RE: PETITION FOR SPECIAL EXCEPTION : BEFORE THE ZONING COMMISSIONER
W/S Craddock (existing) La., : OF BALTIMORE COUNTY
285' N of Centerline of :
Reisterstown Rd., 3rd District :
HOWARD S. BROWN, et al., : Case No. 86-287-X
Petitioners :

RE: Item No. 169 - Case No. 86-287-X
Petitioners - Howard S. Brown, et al
Special Exemption Petition

Plat to Accompany Petition
for Special Exception

PLANTING PLAN: BROWN PROPERTY

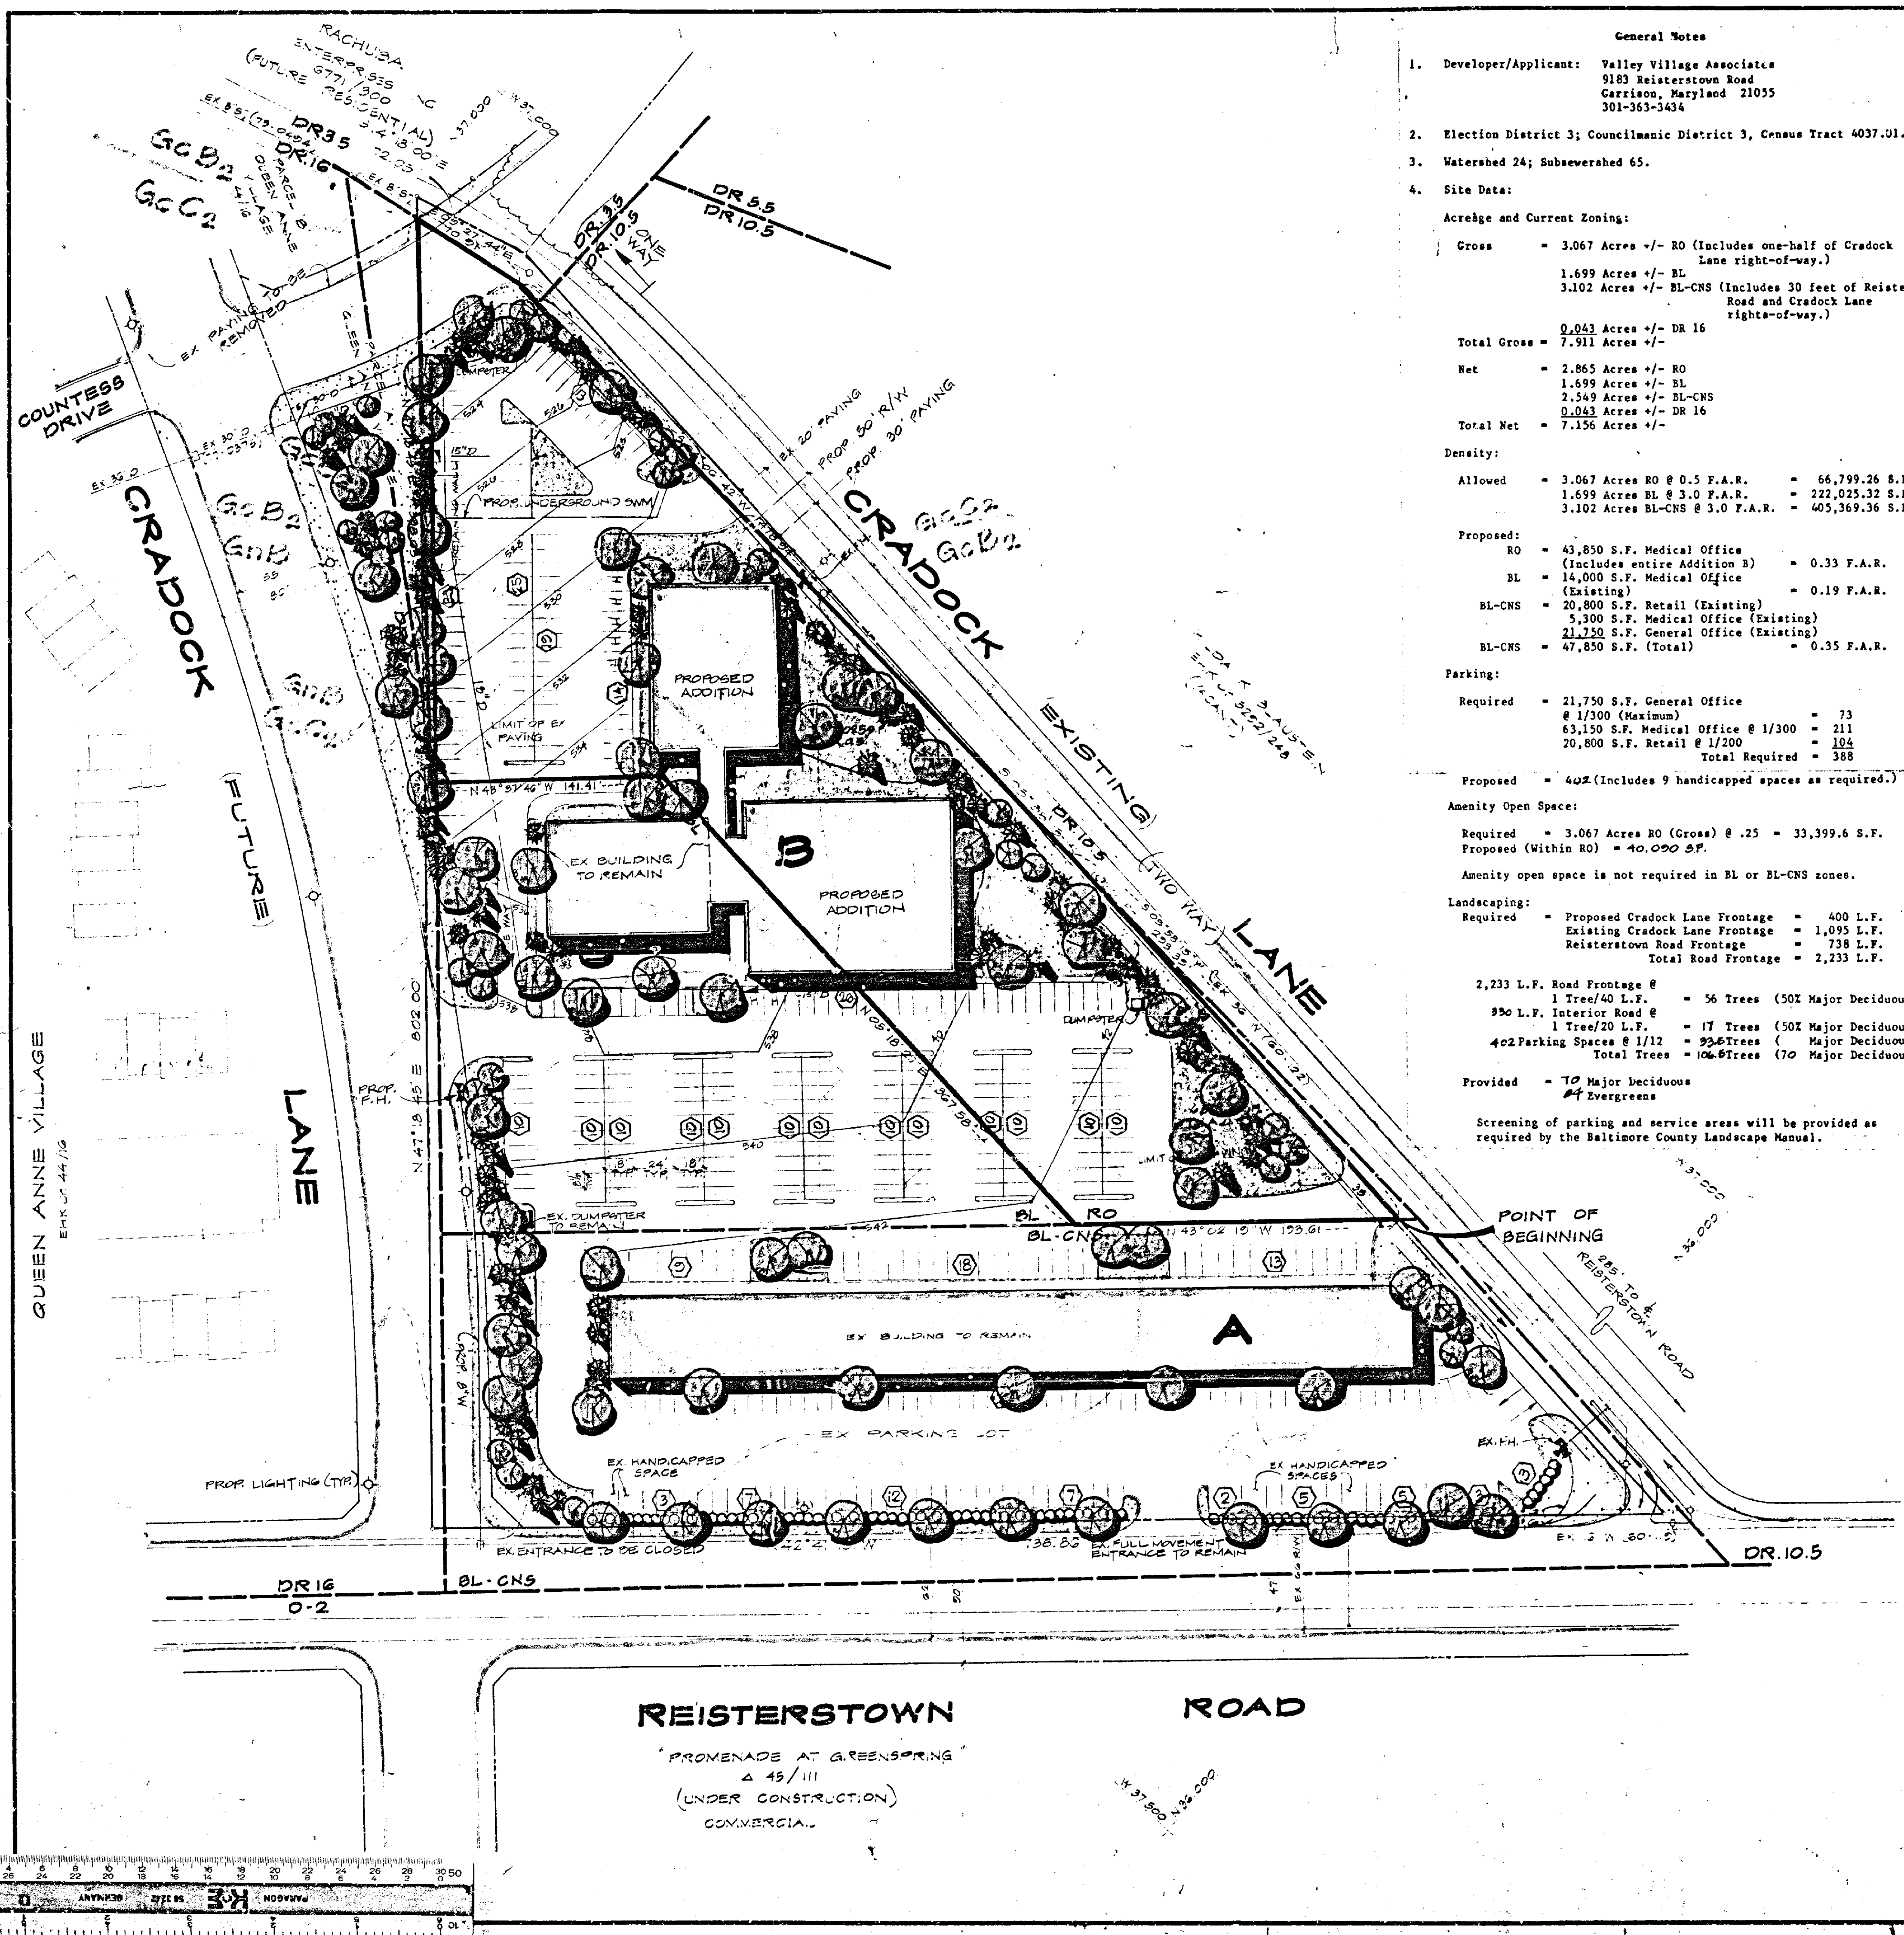
- ☐ There are no site planning factors requiring comment.
 - ☒ A County Review Group Meeting is required.
 - ☒ This site is part of a larger tract therefore it is defined as a subdivision. The plan must show the entire tract.

- ☒ A record plat will be required and must be recorded prior to issuance of a building permit.
 - ☒ The circulation on this site is not satisfactory.
 - ☒ The parking arrangement is not satisfactory.

- ☒ Parking calculations must be shown on the plan.
 - ☒ Development on these soils is prohibited.
 - ☒ Construction in or alteration of the floodplain is prohibited under the provisions of Section 62-28 of the Development Regulations.
